ENQUIRY REGARDING ROADS AND MARITIME SERVICES RESPONSE FOR CONSTRUCTION OF HOTEL – 548-552 PACIFIC HIGHWAY, ST LEAONARDS

DEMOLITION AND CONSTRUCTION OF A HOTEL WITH BASEMENT CAR PARKING 548-552 PACIFIC HIGHWAY, ST LEONARDS

PROPOSED CONSTRUCTION OF A HOTEL WITH BASEMENT CAR PARKING 548-552 PACIFIC HIGHWAY, ST LEONARDS

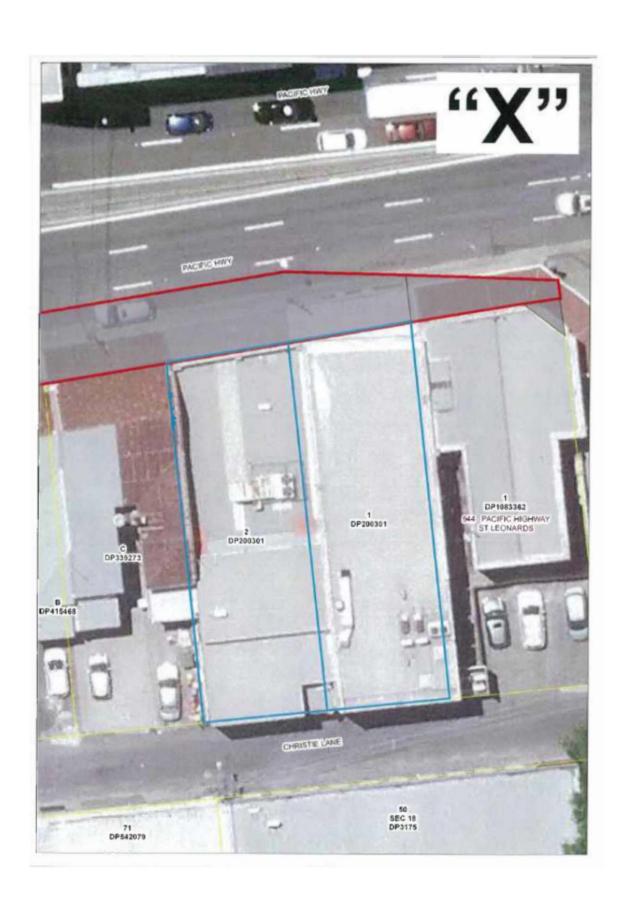
Roads and Maritime has previously resumed & dedicated a strip of land as road along the Pacific Highway frontage of the subject property, as shown by grey colour on the attached Aerial – "X".

All buildings and structures (other than standard pedestrian footpath awnings) together with any improvements integral to the future use of the site are to be wholly within the freehold property (unlimited in height or depth), along the Pacific Highway boundary.
